2.9 Individual Responses to Comments from Organizations

2.9.1 Brisbane Baylands Community Advisory Group (BBCAG)

Figure 1
 Brisbane Baylands Enhanced Transit Scenario
 Developer-Sponsored Plan (DSP)

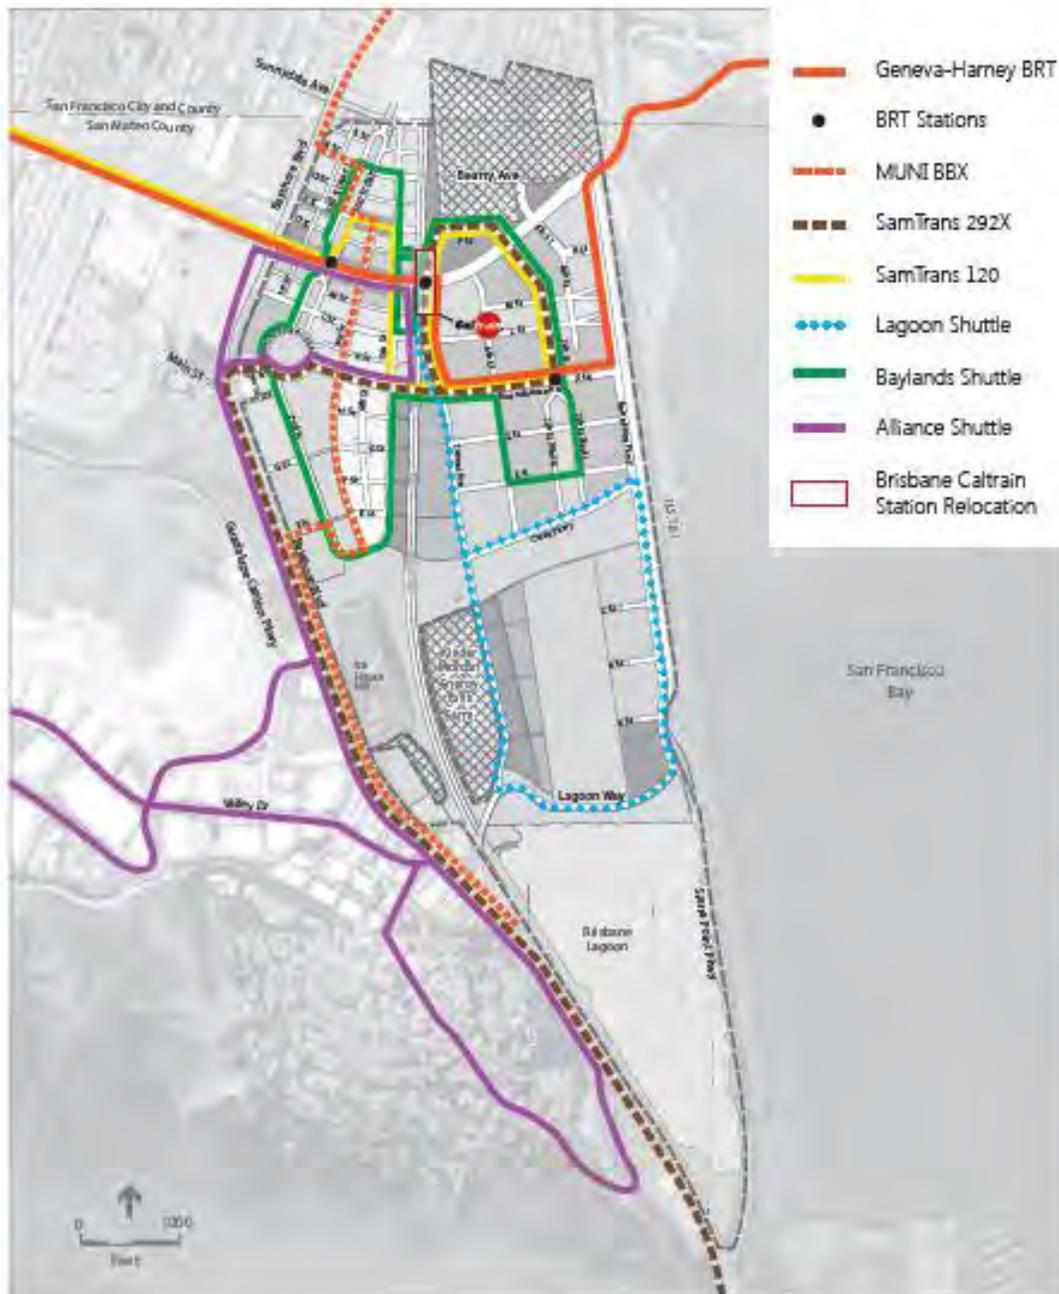
The enhanced transit analysis includes specific modifications and additions to the planned transit improvements of those agencies to maximize mobility and accessibility for the entire Baylands Project Site, addition of new regional transit routes, and addition of new internal shuttles that would enhance connectivity to regional transit facilities. **Figure UPC 1-3.1** illustrates the proposed transit improvements that would complement Project Site development under enhanced transit conditions.

The enhanced transit improvements used in following analysis encompass the basic principles of maximizing transit alternatives and frequency of service (mobility) and minimizing the walking distance from station or stop to origin or destination (accessibility).
